**Request For Referral To PCZBA - Old Hicks & Checker Road  
Fidelity Wes Builders**

**TO:** David Lothspeich; Village Manager  
**FROM:** James M. Hogue, Village Planner  
**DATE:** April 6, 2015  
**RE:** Review of Iverson/Demar Annexation Agreement

Re: Iverson Property Residential Development  
Northwest Corner of Old Hicks Road and Checker Road  
Pre-Application Review

**Site plan** – the following are my comments concerning the site plan submitted with the annexation agreement as prepared by IG Consulting Inc. (IG#14604) & dated (as revised) 3.3.15.

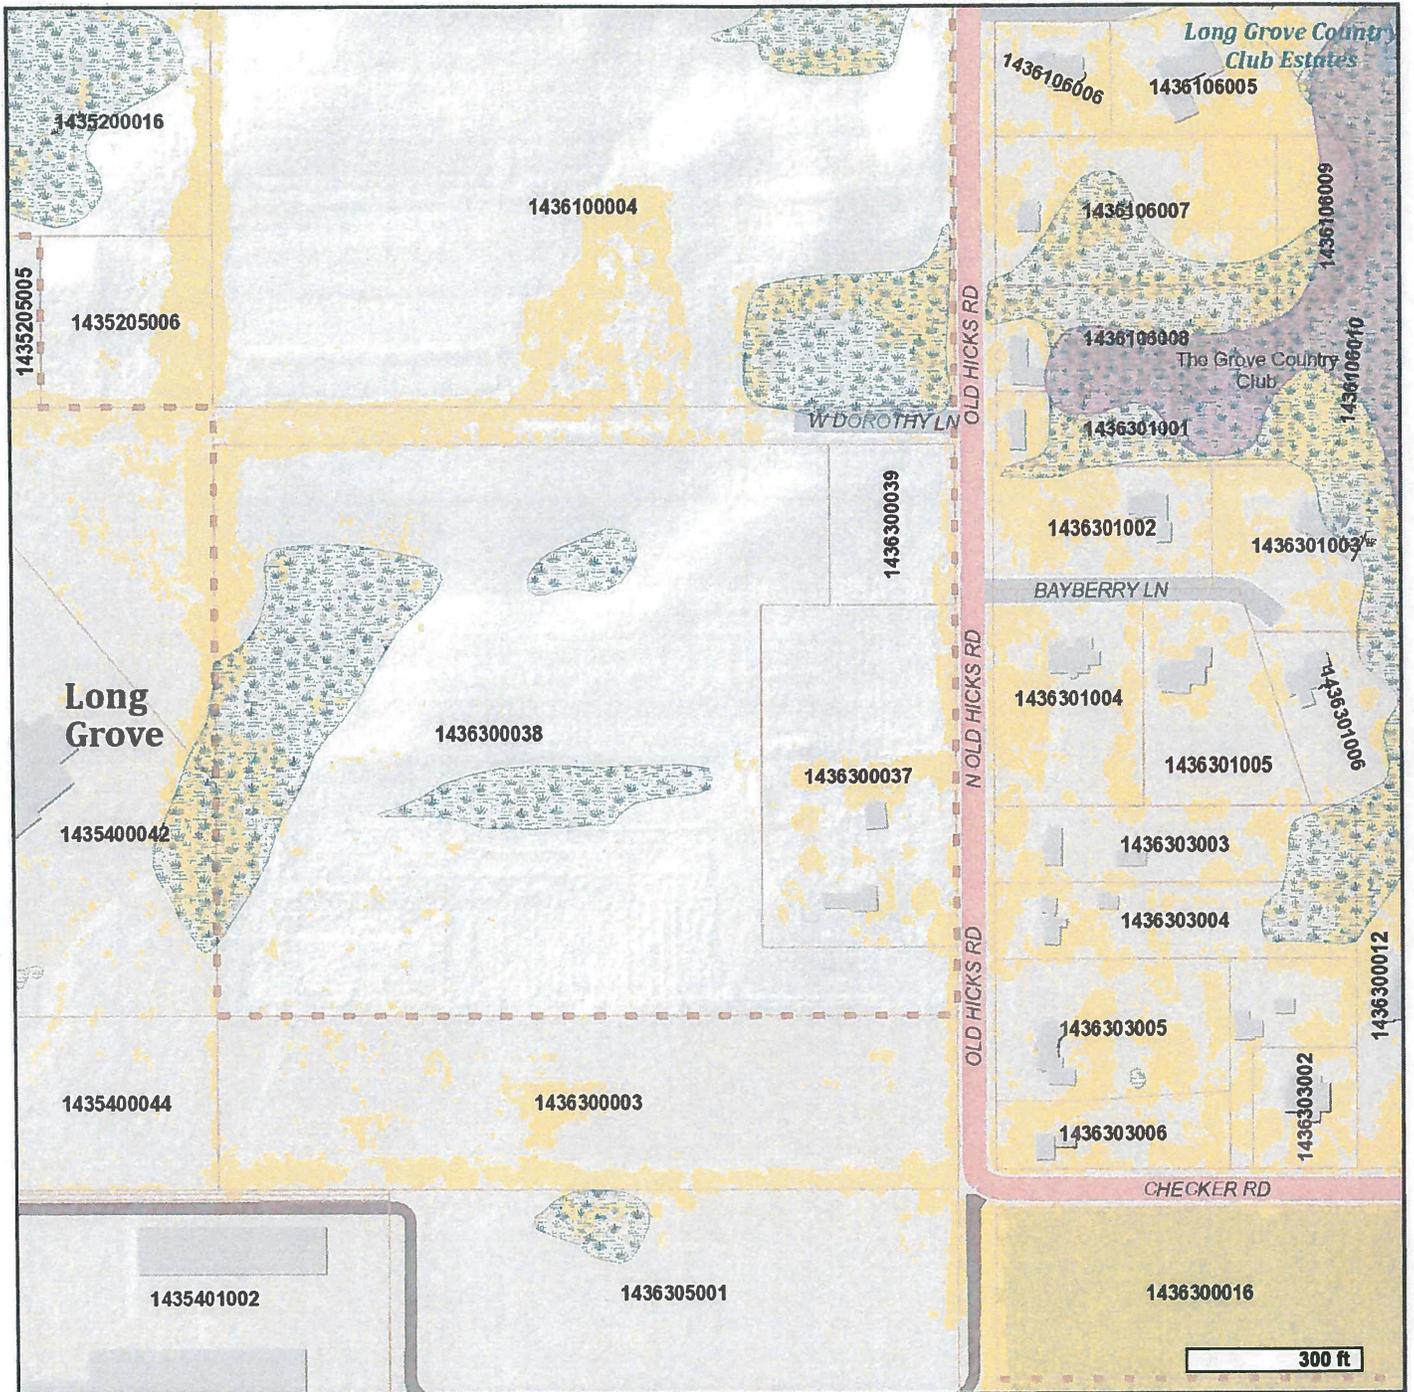
- As previously noted the site plan and annexation agreement do not match the number of lots an units proposed by the petitioner.
- Two means of ingress and egress should be provided to the site (i.e. internally connect the north and south access roads).

- The south access road is unnamed.
- How will water service be provided; particularly to the duplexes ?
- Conservancy soils are not listed; this may have an effect on site density.

- Utilities to the site are not identified.
- Dorothy Lane appears as dedicated right-of- way (ROW); ownership and dedication of the ROW need to be resolved.

- Northern access to the site encroaches into the Dorothy Lane right-of-way as do lots 11,12,13,14, & 15.
- Setbacks on lots 11,12,13,14, & 15 are measured 30' to the centerline of Dorothy Lane and not the edge of the property. Per the Village Code lot area in ROW's (public or private) is not counted as a portion of the lot area (i.e. gross vs. net lot area); the street line constitutes the lot line.

- Lots 9 & 10 are shown as "alternate single family attached buildings"; this not identified in the annexation agreement nor was included as part of the density calculations noted in this review. Lots 9 & 10 were treated as SFR lots for the purposes of this review.

- Portions of the "driveways" on the duplex lots fall outside of the building pad; how will these be maintained?
- Bulk regulations for the duplex lots need to be determined.

- The proposed pathway should be better incorporated in to the entire development.
- Preliminary subdivision platting & engineering are missing.
- Preliminary PUD information is missing; typical submittal items attached.

**PROPOSED RESIDENTIAL DEVELOPMENT**

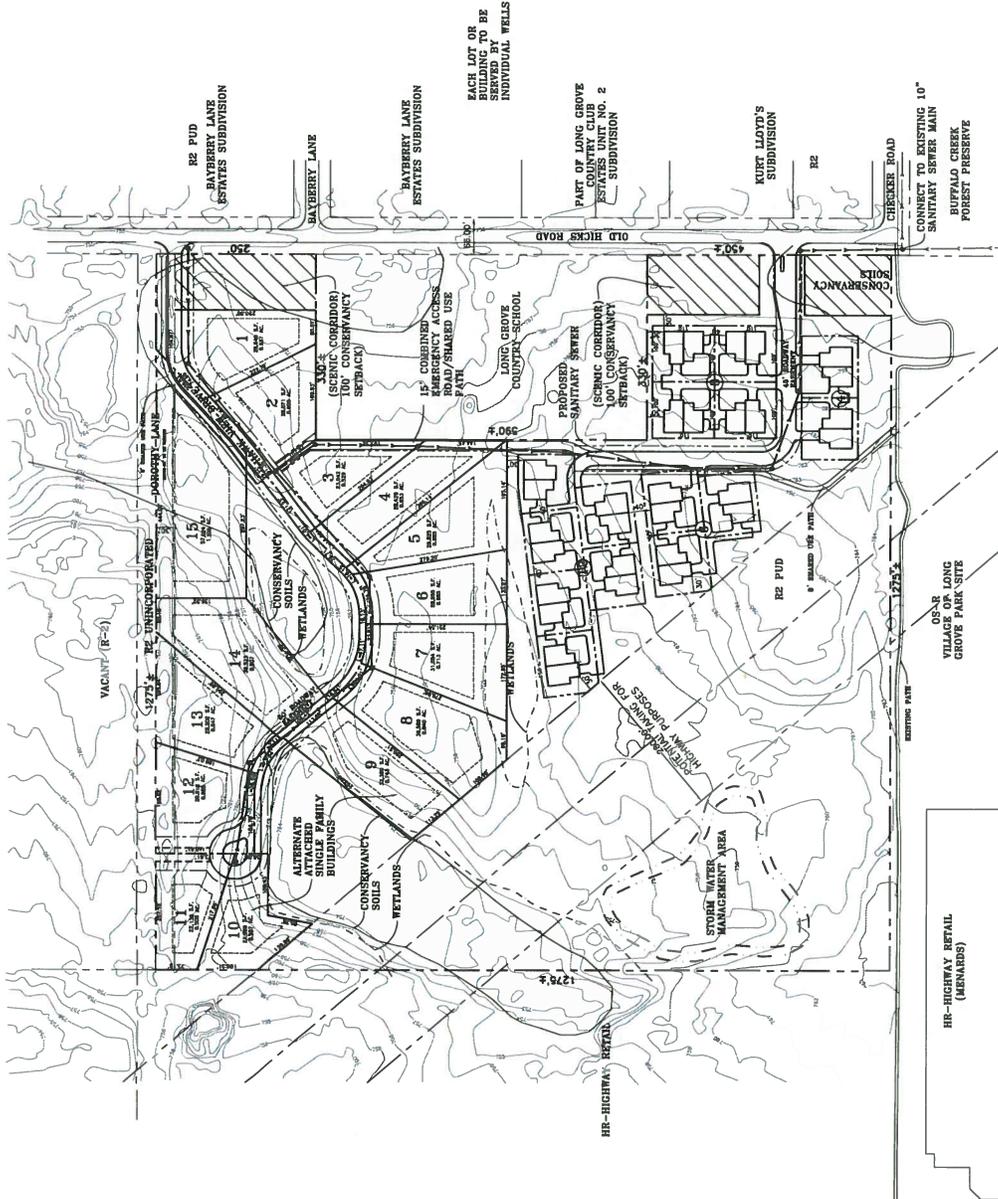
1. Our office did not review the Draft Annexation Agreement or Petition.
2. For Preliminary Approval, the following documents should be submitted:
  - a. Preliminary Engineering Plans, which include preliminary Grading and Utility Plans. In addition to Village Ordinance requirements, the preliminary engineering plans should address the following:

- i. An overflow route must be provided within the subdivision to the stormwater detention basin in accordance with the Lake County Watershed Development Ordinance (WDO). This overflow route must be shown on the preliminary engineering plans. If overflow is considered in appropriately sized storm sewer pipe, the requirements of Article IV.B.1.g(3) of the WDO must be satisfied.

- ii. The sanitary sewer should be extended to the northwest corner of the property to service future development within the ultimate sewer service area. Invert elevations should be shown and loading calculations provided to confirm the required sewer size.

- iii. The proposed water system needs to be presented for approval.
    - iv. In accordance with Article IV.E of the WDO, a wetland submittal is required. The preliminary plan shows wetland limits. The source of these lines needs to be identified and applicable buffers need to be shown.

- v. The Route 53 Right-of-Way (ROW) take should be confirmed. We believe it is 300.'
  - b. Preliminary Hydraulic Study. This will be a Major Development; please follow the applicable requirements in the WDO.

3. Our office is concerned with the long-term viability of the detention basin at the southwest corner of the property per the following:

- a. Access to the basin needs to be shown for the proposed condition and thought needs to be given for access if/when the Route 53 extension is constructed.
- b. Per the Blue Ribbon Advisory Council (BRAC) Report, dated June 7, 2012, the section of Route 53 in this location is contemplated to be "Depressed Roadway." Depressed roadway is "depressed below grade and bermed with wide median..." per the BRAC Report.

The anticipated grading for the Route 53 extension is a large unknown. We recommend that the applicant perform a preliminary grading evaluation to determine what this grading may look like, if it has an effect on the storm sewer depths and if it will ultimately result in a basin that is too low to have a natural, gravity outlet. Based on the grading, there is potential that the development of Route 53 will block any drainage and/or overflow path.

4. We do not recommend the Dorothy Lane ROW be abrogated. We recommend that the northern Old Hicks Road access be centered in the ROW to service any future development of the property to the north. The northern lots will need to be adjusted accordingly.
5. We recommend that the south and north accesses to Old Hicks Road be interconnected via hardscape pavement.
6. Connection to the sanitary sewer in Checker Road will require payment under the terms of the Menard's Recapture Agreement. A separate Recapture Agreement should be considered for the main to the northwest corner of the property.
7. In accordance with Article IV, Section B.2.b (17) of the WDO, a subsurface drainage inventory is required for the proposed Major Development.

8. The stormwater detention basin appears to be undersized. The detention basin should be sized such that the vertical distance between the normal water level and high water level is 4-feet or less.
9. In accordance with Article IV.B.1.a (9) of the WDO and state law, notification must be made to the proper highway authority of development adjacent to a state or county right-of-way (ROW) and request that the proper highway authority provide, at the cost of the highway authority, the amount of additional stormwater capacity in the detention facility for any future roadway development. Further study of the Route 53 extension timing will be required to determine if this section of the Ordinance and State Law applies.
